Re: General Order (G.O.) 112-F Compliance Inspection of Pacific Gas and Electric's Pipeline Construction and Material Traceability Audit.

Pacific Gas and Electric Company (PG&E) submits this response to the Safety and Enforcement Division's (SED) Post-Inspection Summary of Inspection Findings (Summary) received March 18, 2024, stemming from the 2023 SED inspection of PG&E's Pipeline Construction and Material Traceability records conducted August 21 – 28 and August 28 – September 1, 2023.

Figure 1. Station Project S-1137 As-built Drawing

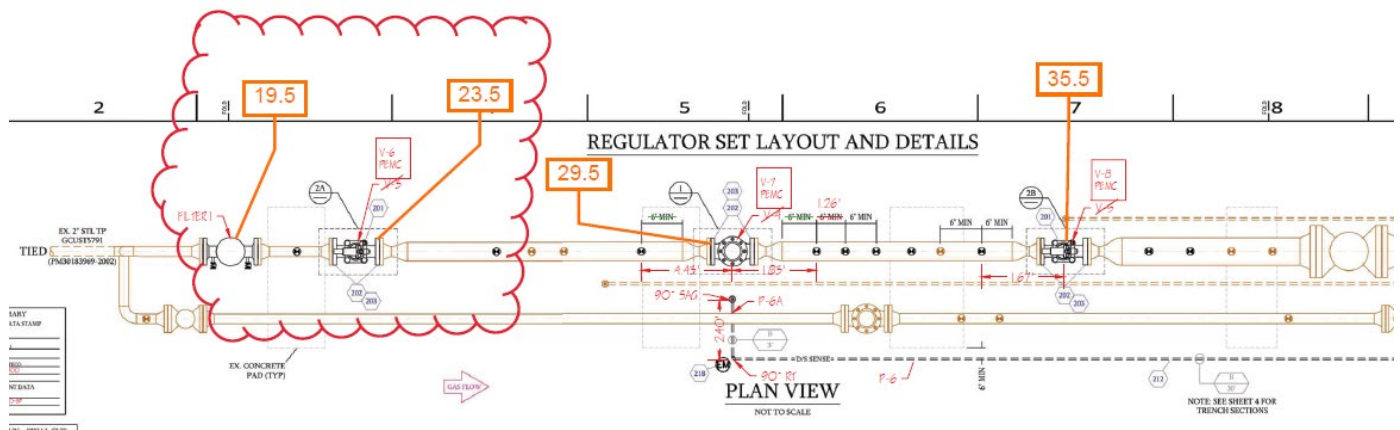
SED reviewed PG&E's construction documentation for project S-1137 and determined that the 2-inch regulators (2" X 1" Mooney Flow Grid) V-6 and V-8 noted on the as-built drawing were not in the Component Receiving Log or Valve Receiving Log that PG&E provided to SED during the audit. SED requested PG&E to provide the receiving log for those regulators, but PG&E was unable to provide a Component Receiving Log that showed the regulator valves V-6 and V-8.

PG&E's representative explained that the regulator valves were not included in the PG&E's Material Traceability Scope log because components that are 2 inches or less were not required to be documented. PG&E stated that its material traceability scope outlined in Standard TD-4030S covered only components greater than 2 inches with yield strength grades of 42,000 psi or greater. Also, PG&E stated that it did not classify the regulators as valves, hence, PG&E does not have to record the regulators in the component receiving log. However, PG&E Standard TD-4030S requires material traceability record for valves of all diameters, and the specification sheet from the manufacturer of the 2" X 1" Mooney Flow-Grid

regulator describe it as a “Pilot Operated Valve”. The As-Built Drawing did not match the Bill of Materials (BOM).

SED consulted PHMSA’s subject matter expert on whether a Pilot Operated Regulator is a Valve and falls under the Valve category for material traceability. PHMSA’s response was “Yes, the 2” x 1” Mooney Flow Grid regulator is used to control flow and pressure and hence it is a valve.”

PHMSA indicated that the Mooney Flow Grid regulator is a valve. Therefore, PG&E is in probable violation of G.O. 112-F Reference Title 49 CFR, Part 192 Section 192.205(a) for not documenting each valve in its Component Receiving Log as part of the as built records.

PG&E appreciates that SED consulted with PHMSA’s subject matter expert on the Mooney Flow Grid regulator. PG&E reviewed the interpretation and maintains that the Mooney Flow Grid regulator in question is not a valve subject to the material traceability requirements of Section 192.205(a). Although the Mooney Flow Grid regulator is described as a “pilot operated valve” in the manufacturer specification sheet, the component is a pressure regulator; therefore, it is classified as a fitting pursuant to Section 192.205(a). 49 CFR Part 192.145 notes that valves must meet the minimum requirements of ANSI/API Specification 6D (API Spec 6D), which is incorporated by reference in 192.145. API Spec 6D lists various types of valves, but it does not include pressure regulators like the Mooney Flow Grid regulator, which is not built per API Spec 6D. With regards to material traceability requirements set forth in 192.205(a), PG&E notes that the American Society of Mechanical Engineers (ASME) B31.8, “Gas Transmission and Distribution Piping Systems – ASME Code for Pressure Piping,” upon which many of the 49 CFR 192 requirements are based, includes separate definition sections for regulators (803.6) and valves (803.7). This suggests that these are not intended to have the same meaning in the context of 192.205(a). PG&E would like to request an additional interpretation from PHMSA including this more detailed information to validate if the Mooney Flow Grid regulator is a valve pursuant to Section 192.205(a) and whether the Mooney Flow Grid regulator meets the criteria for inclusion in the Component Receiving Log or Valve Receiving Log.

If the Mooney Flow Grid regulator is considered a valve for the purposes of material traceability, the documentation required by 192.205(a) is provided on the Drawing, Bill of Materials (BOM), and Gas Design Standard (GDS), all of which have correlation through the Item number and Material Code. The 2” x 1” Mooney Flow Grid regulator in question is indicated below as Item #201 on the Drawing (Figure 1), which correlates to Item #201 on the BOM (Figure 2). Additionally, GDS H-80 (Figure 3) specifies the standard and pressure rating.

Figure 5. R-445, As-built drawing

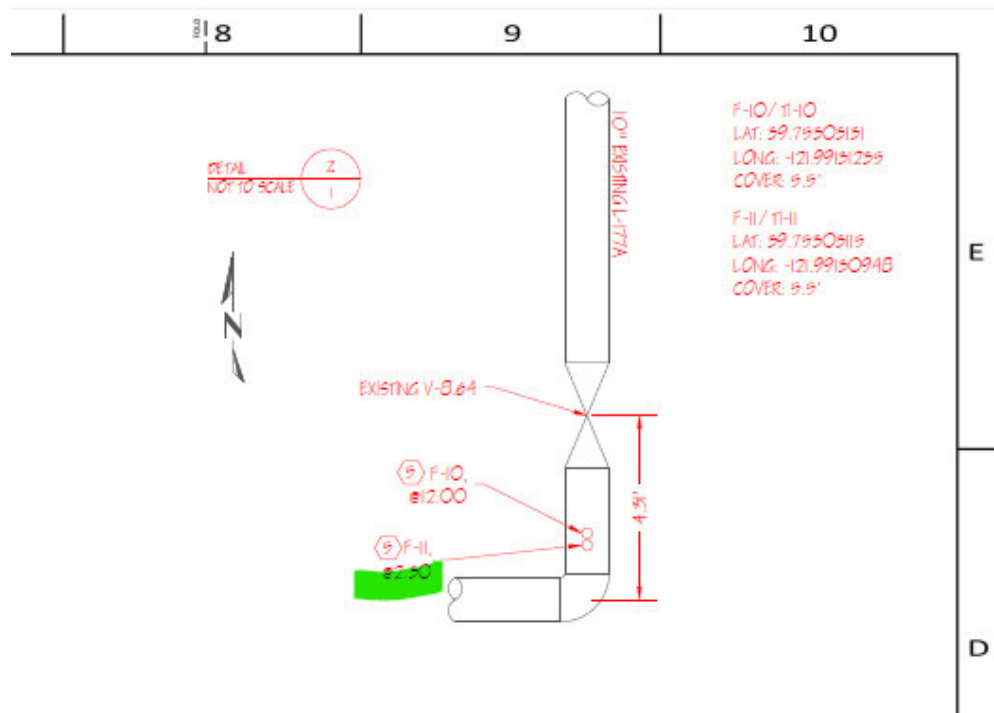
Issue Summary On the Project –R445 weld map, PG&E indicated the description of the save-a-valve F11 to be @ the 2:30 location. However, the as-built drawing description showed that the location of F11 was @10:30.

SED recommends PG&E verify the location of the save-a-valve F11 and make the final tie-in weld map description consistent with the as-built drawing.

PG&E disagrees with this finding. Both the as-built drawing (Figure 5) and weld map (Figure 6) indicate save-a-valve F-11 to be at the 2:30 position.

Figure 7. R-445 as-built, Pipe Section P-55

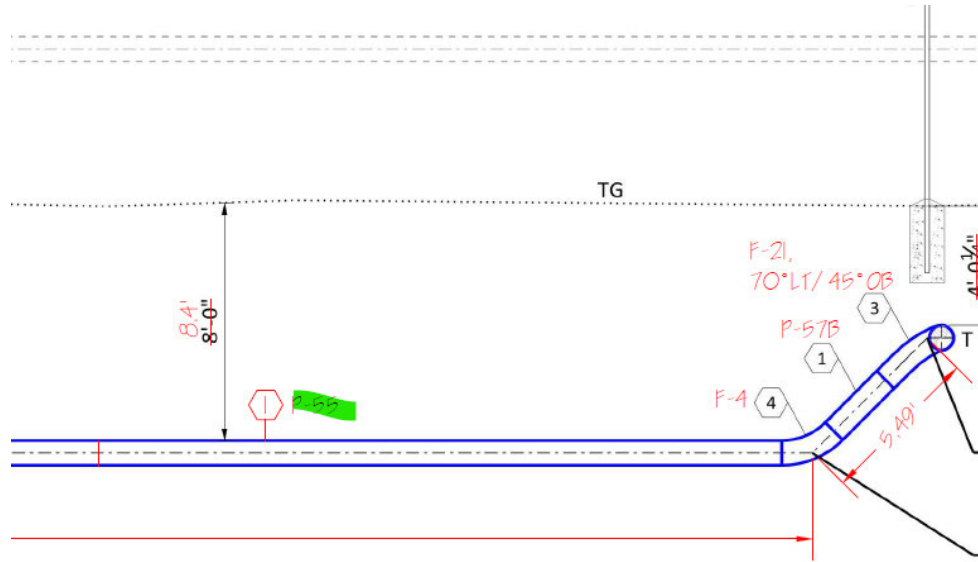
- a. PG&E incorrectly described the location of the Save-a-valve F-25 as 0.5 feet from TW-122, instead of TW-121.
- b. PG&E incorrectly recorded the save-a-valve installed on pipe P-111A as F- without a component number.
- c. PG&E labelled pipe component P-100B twice in the hydrotest weld map (26.52' at STA 0+46.54 and 1.00' at STA 47+29.08). There was another section of 5.54 feet pipe incorrectly labelled P-100 instead of P-100E that was used for the hydrotest tie-in. In SED's data request (DR) #24, PG&E clarified that the 26.52 feet of P-100B should have been listed as P-100D. P-100 was cut out and used for fit-up at the tie-in location and became P-100C. P-100A, P-100B, and P-100D were cut out after the hydrotest and removed from the permanent pipe section and were not put into service.
- d. Pipe section P-55 (28.17' at STA 46+12.28) was incorrectly labelled as P-55A.

- c. PG&E agrees; however, as noted PG&E provided SED with traceable documentation that substantiated the correction and that the corrections were made, in the response to data request (DR) #24.
- d. PG&E disagrees with this finding. Both the as-built drawing (Figure 7) and hydrotest weld map (Figure 8) depict P-55.
